Attorney Docket No. LUKP:123US  
U.S. Patent Application No. 10/711,823  
Reply to Office Action of April 19, 2006  
Date: August 10, 2006

**Amendments to the Drawings**

The attached sheet of drawings includes changes to Sheet 2. This sheet, which includes Fig. 3, replaces the original sheet including Fig. 3. In Figure 3, previously omitted element guide shoe parts **38** has been added.

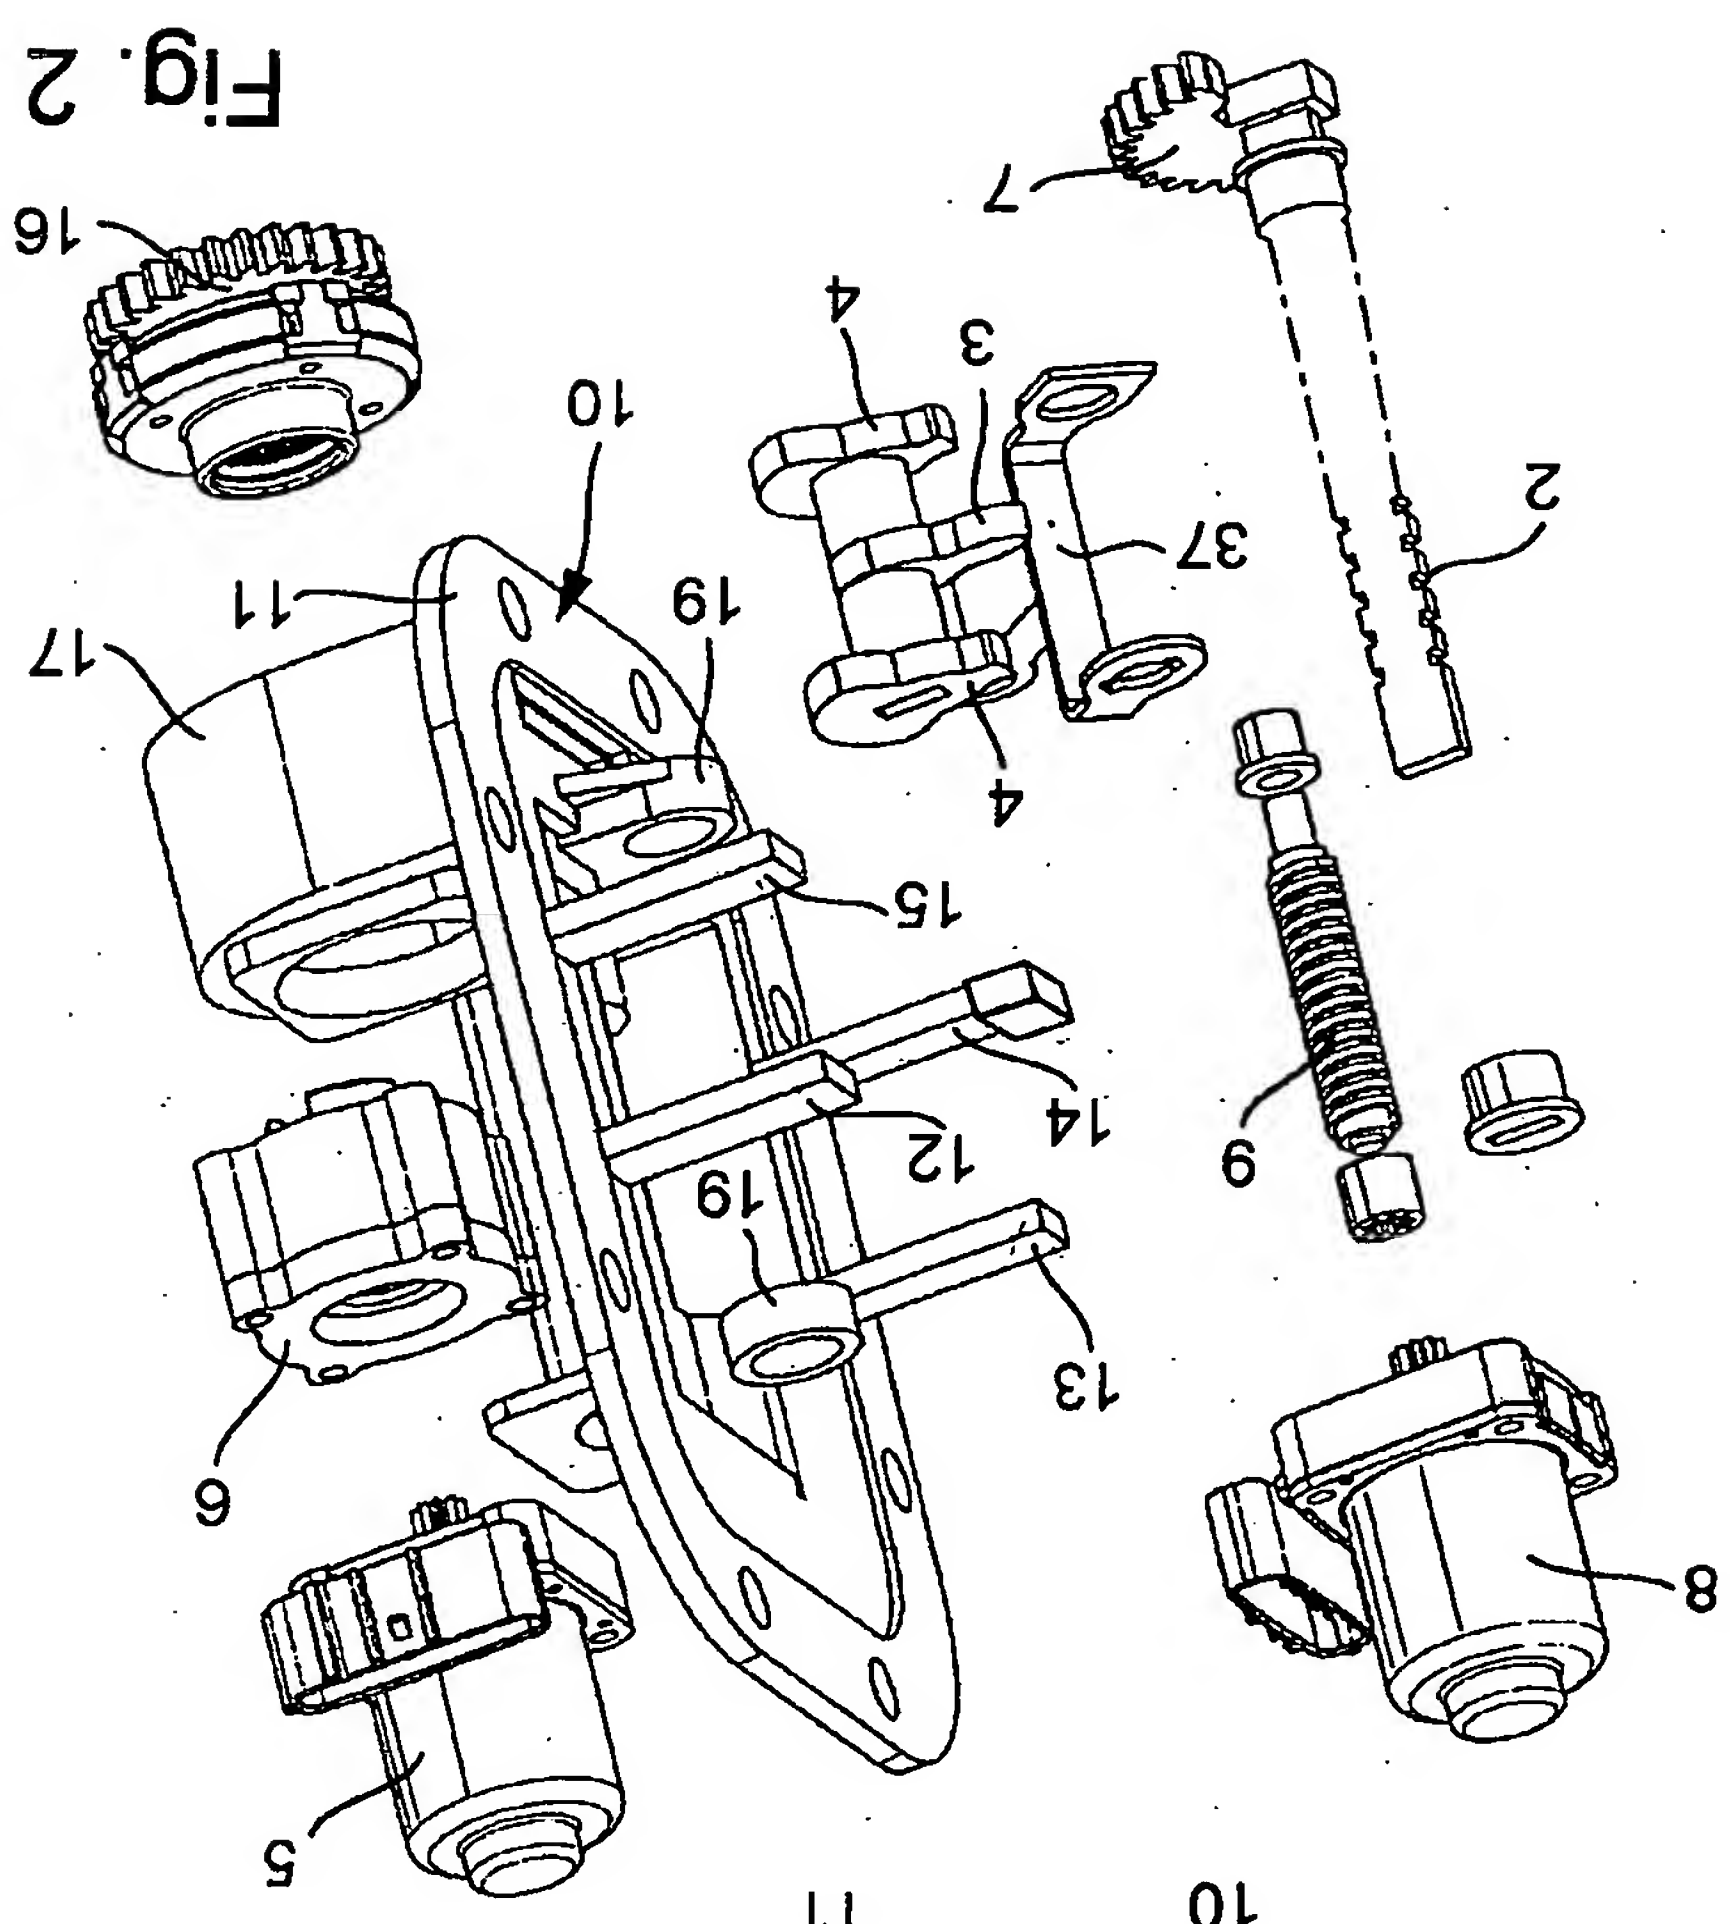
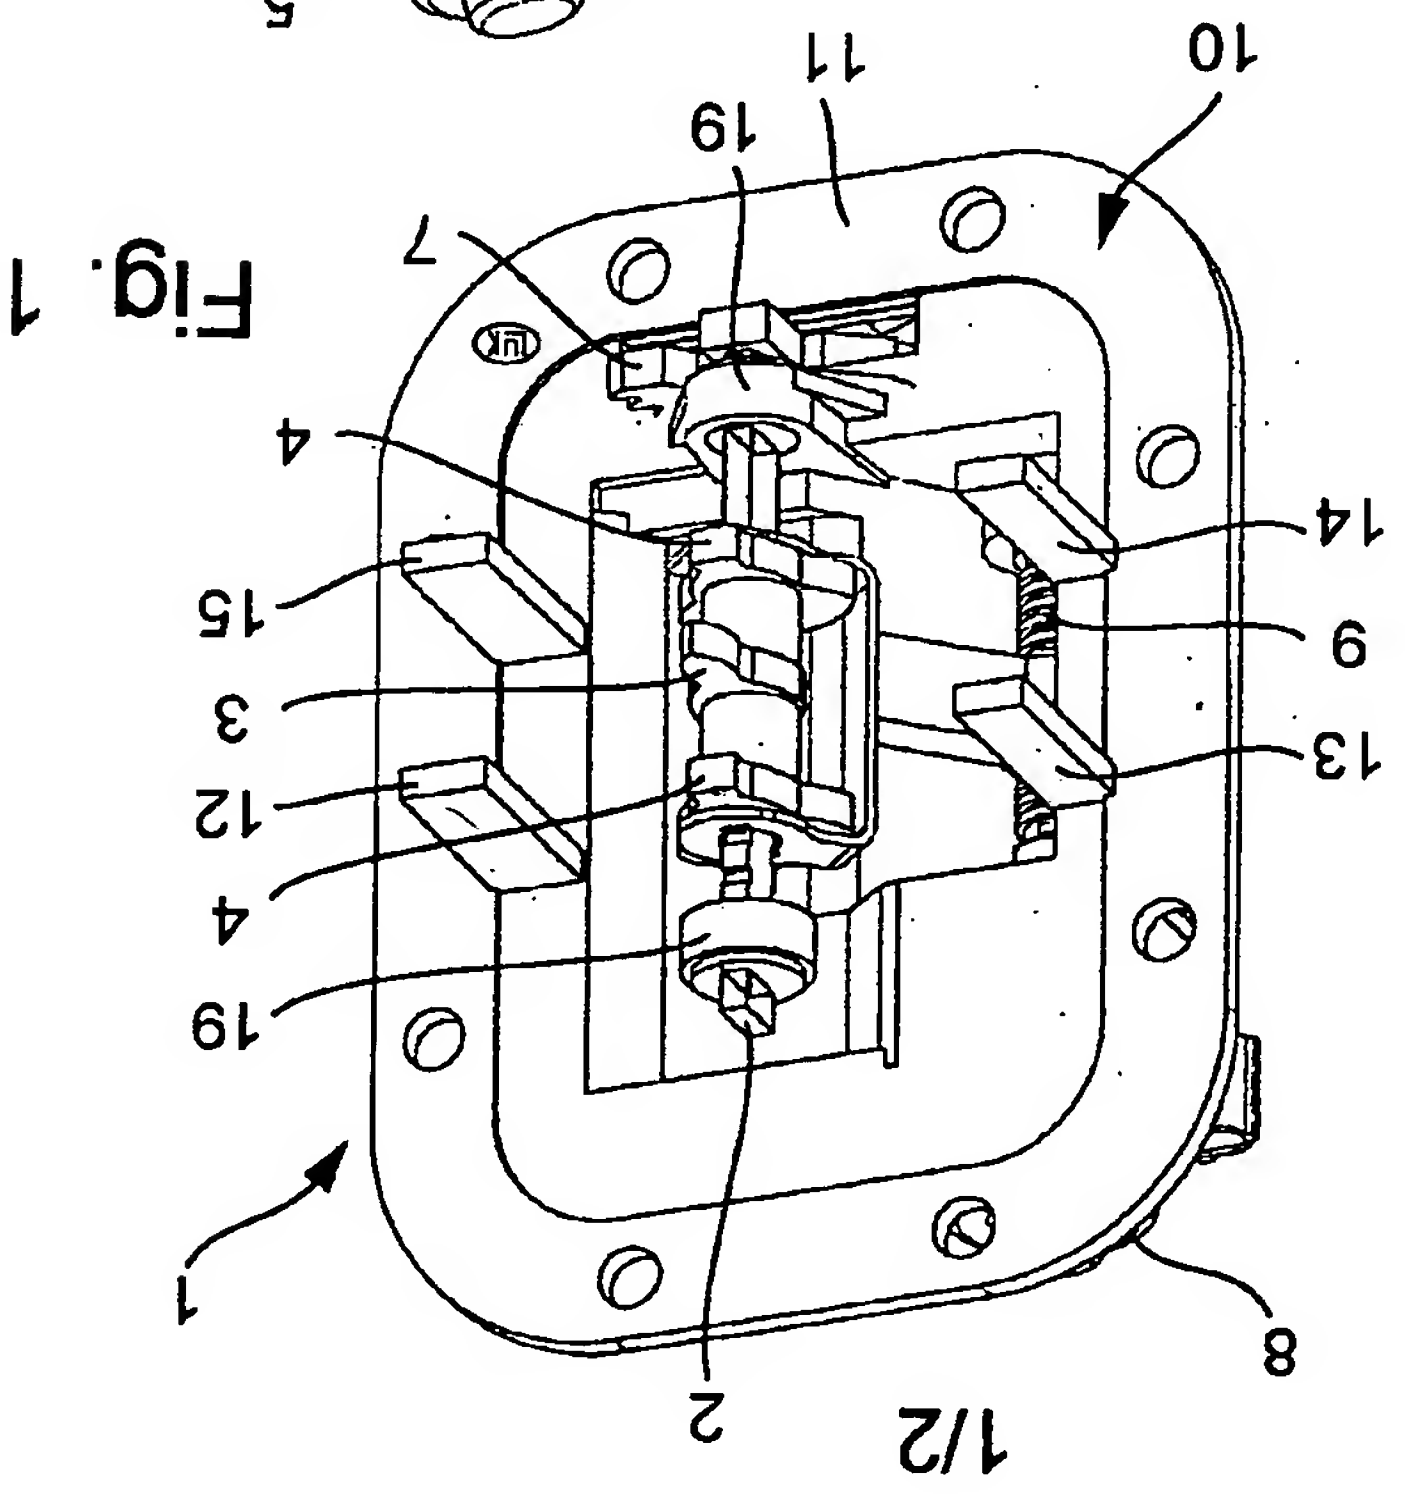
The Examiner objected to the drawings under 37 CFR §1.83(a) as not showing every feature of the invention specified in the claims. Specifically, the Examiner stated that the bearing arrangement consisting of two symmetric jibs, as claimed in Claims 6 and 7 and the guide rail parts at their ends resting against the gearshift rails, as claimed in Claim 8 must be shown.

Regarding the guide shoe parts, Applicants have amended Figure 3 to show guide shoe parts **38** on protruding rods **32** and **33** and resting against the gearshift rails. Applicants respectfully point out that both original Figure 3 and amended Figure 3 show the packet of gearshift rails **26-28** supported by protruding rods **32** and **33** as is claimed in Claim 6. Applicants respectfully request reconsideration and removal of the objection to the drawings as regards Claim 8.
